Dominion Nuclear Connecticut, Inc.  
Millstone Power Station  
Rope Ferry Road  
Waterford, CT 06385

December 3, 2004

**DOMINION NUCLEAR CONNECTICUT, INC. (DNC)**  
**MILLSTONE POWER STATION UNITS 2 AND 3**  
**RESPONSE TO REQUEST FOR ADDITIONAL INFORMATION**  
**LICENSE RENEWAL APPLICATIONS**

Figure 1  
Millstone Unit 2  
Containment Tendon Prestress  
Dome Tendons

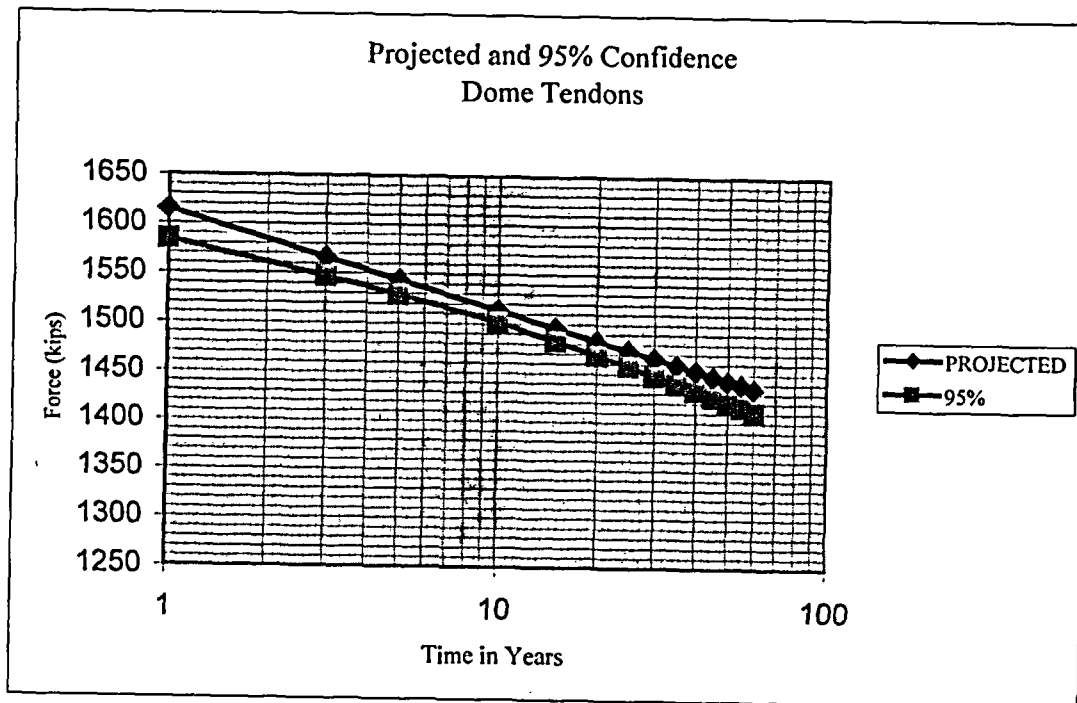
The process used by the license renewal applicants with prestressed concrete containments, is to assume that the tendon force varies with the logarithm of time (as explained in Regulatory Guide 1.35.1). It is not apparent in figure 4.5-1, what functional relationship has been assumed between the two variables. The applicant is requested to provide additional information regarding the process used in arriving at the trending curves shown in Figure 4.5-1.

Consistent with Regulatory Guide 1.35.1, the containment dome, horizontal and vertical tendon surveillance results (Millstone Unit 2 LRA, Section 4, Tables 4.5-1, 4.5-2 and 4.5-3) used in the development of LRA Figure 4.5-1 have been plotted in the following Figures 1, 2 and 3, against the logarithm of time using the methodology identified in Attachment 3 of NRC Information Notice 99-10. Prestressing forces for the Millstone Unit 2 containment dome, horizontal and vertical tendon are shown to vary linearly with time. Further discussion and information on the development of these curves can be found in the responses to RAI 4.5-2, RAI 4.5-4 and RAI 4.5-7.
